SUBJECT: Forwards clarifications &/or addl info re 830830 & 0906 & 09 responses to SSER 18 open items, Items 3, 4, 7, 10 & 19 resolved, Encl info resolves Items 1, 16, 17, 18, 23, 24 & 27.

Re: Docket No. 50-275, OL-DRP-76
Diablo Canyon Unit 1
Safety Evaluation Report, Supplement No. 18

ENCLOSURE 1

Freehand Averaging of Spectra (SECY-83-366, Enclosure 5, Item 1)

Attachment 1

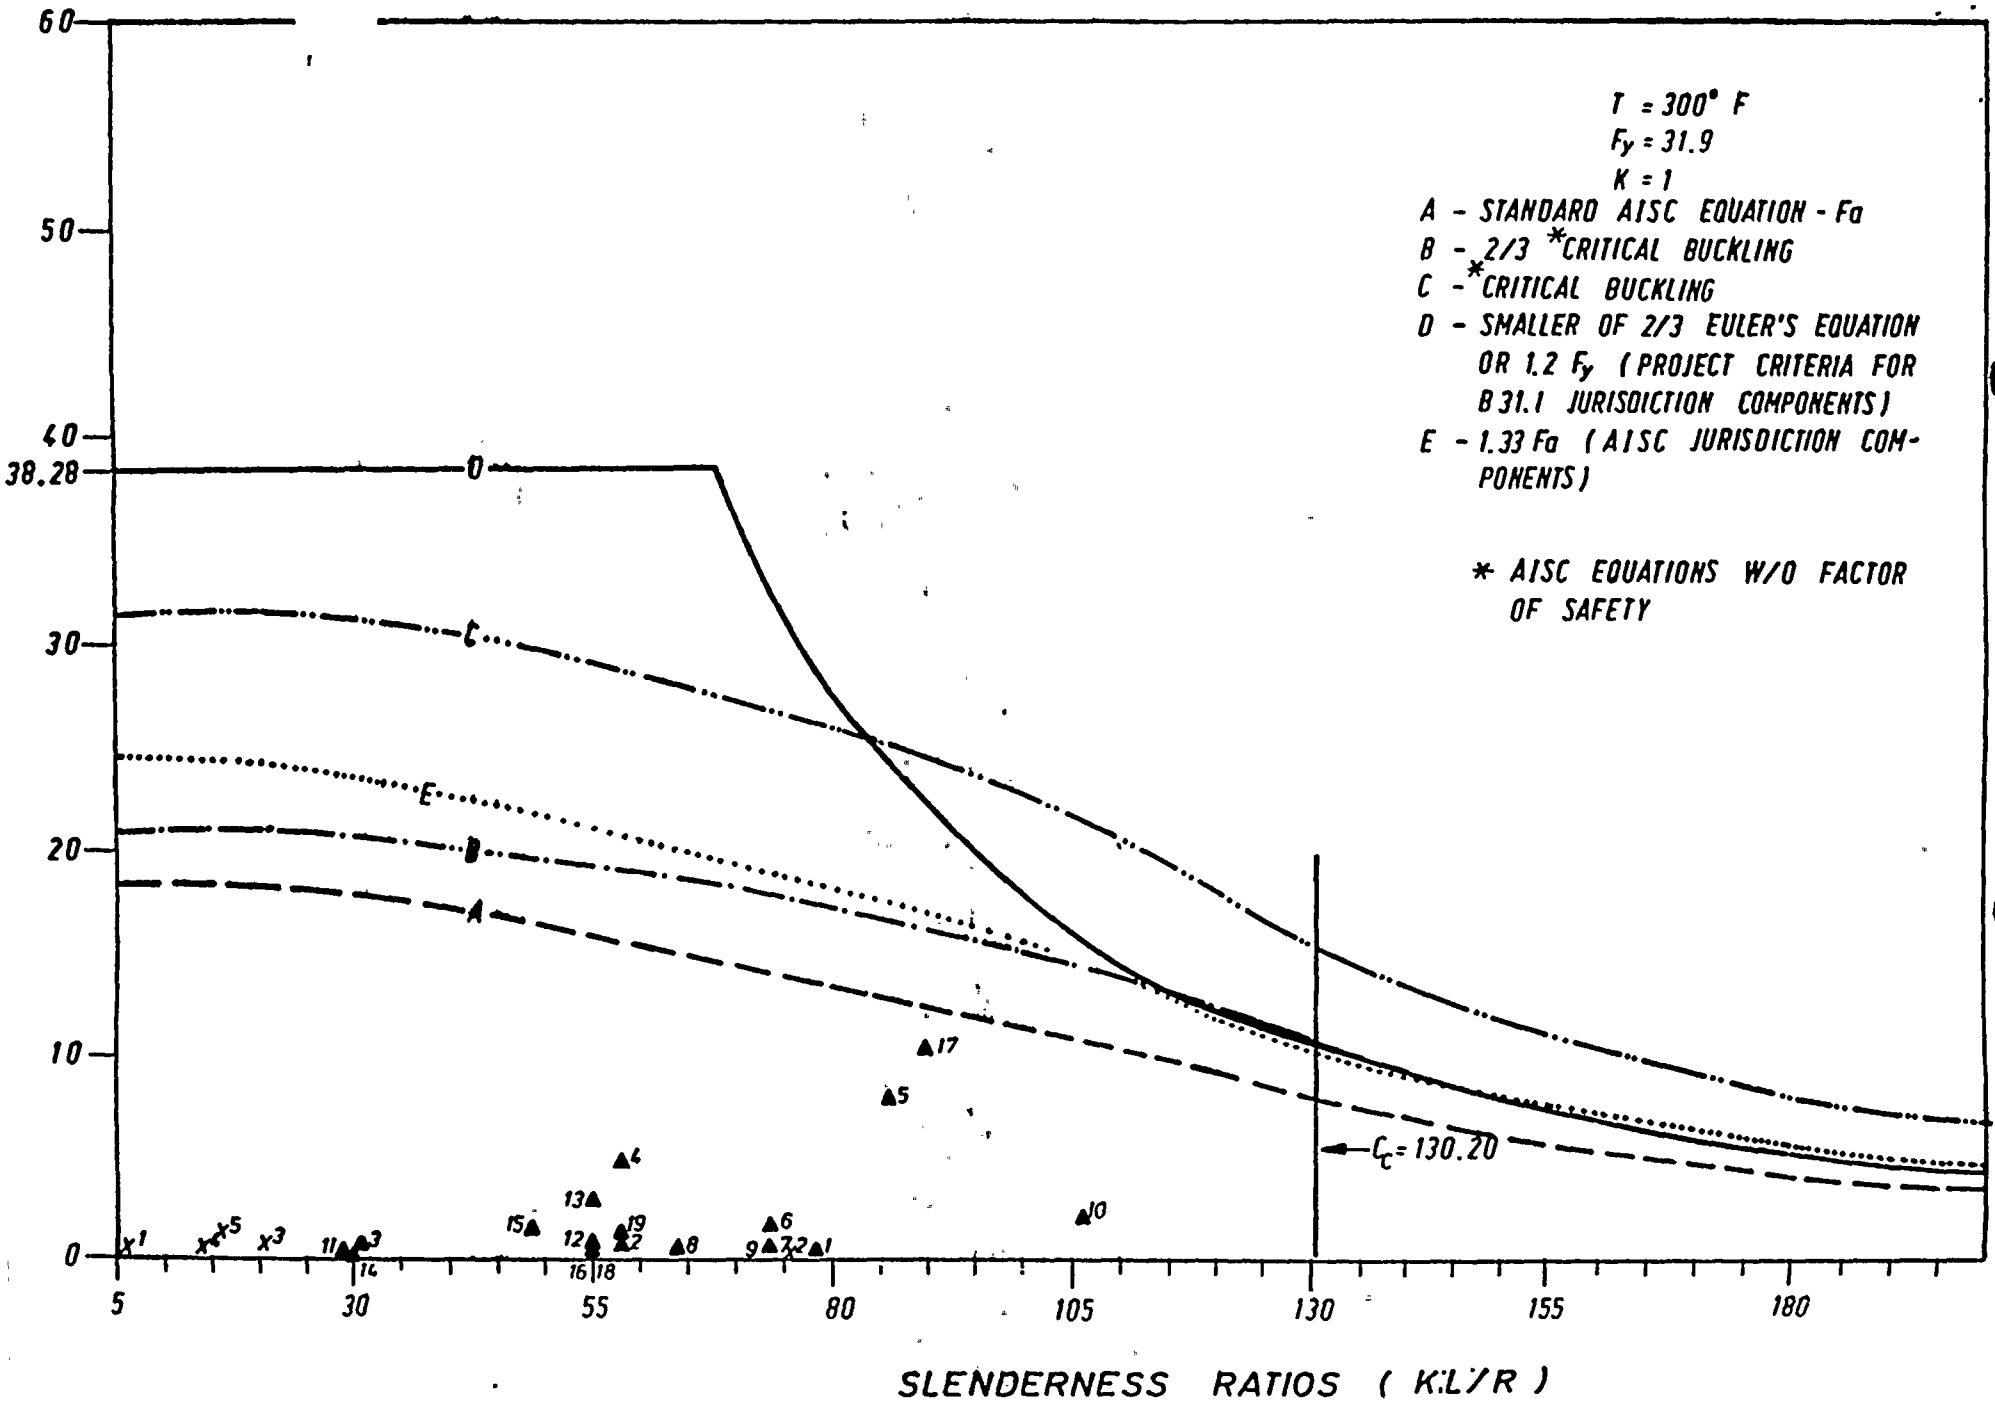
ITEM 17: "Buckling criteria for linear supports, specifically the Euler buckling equation for calculating critical buckling loads for all slenderness ratios, should be evaluated and justified (C.3-48)"

Buckling criteria for piping supports was stated in the FSAR in the Hosgri amendment. Since the B31.1 Code does not address buckling, the Project criteria document for pipe supports, DCM M-9, states rules for the design of pipe supports and provides additional stipulations that increase the conservatism of the FSAR commitments for standard components. This criteria for faulted conditions require that members be capable of sustaining a load of 2/3 of critical buckling or $1.2 F_y$, whichever is smaller. (Critical buckling is defined as Euler buckling.) This criteria is in agreement with Appendix F of the ASME Code Section III.

*Critical buckling in this case will be defined as the AISC curve without safety factors (curve C in Attachment 1).

In a meeting with Staff on September 28, 1983, this criteria was discussed in light of a new interpretation and pending revision to Appendix F. Dr. Hartzman explained that the new revision to Appendix F will require 2/3 critical buckling* with an allowed increase for very small slenderness ratios.

In that meeting, DCP explained that this allowable most probably would not govern the design. Bending stresses usually govern; further, combined axial and bending stresses use an interaction equation. However, in order to bring the concern into perspective, the DCP has selected for study 24 typical cases of standard components where the slenderness ratio is below C_c . The results of that study are presented in Attachment 1, where the cases are designated by number. The cases where $KL/R < C_c$ are virtually limited to short stanchions and "T shoes". As can be seen from the graph, case 17 is the limiting case and is approximately 60% of 2/3 critical buckling (AISC without safety factors).

We believe that this study demonstrates that the critical buckling issue is not a concern regardless of the criteria chosen for the allowable. We further believe that the Project criteria as stated in the PSAR is consistent with interpretations applied to Appendix F as it now exists. For these reasons we believe the Project criteria as it now stands is adequate to control buckling in the pipe supports at Diablo Canyon.
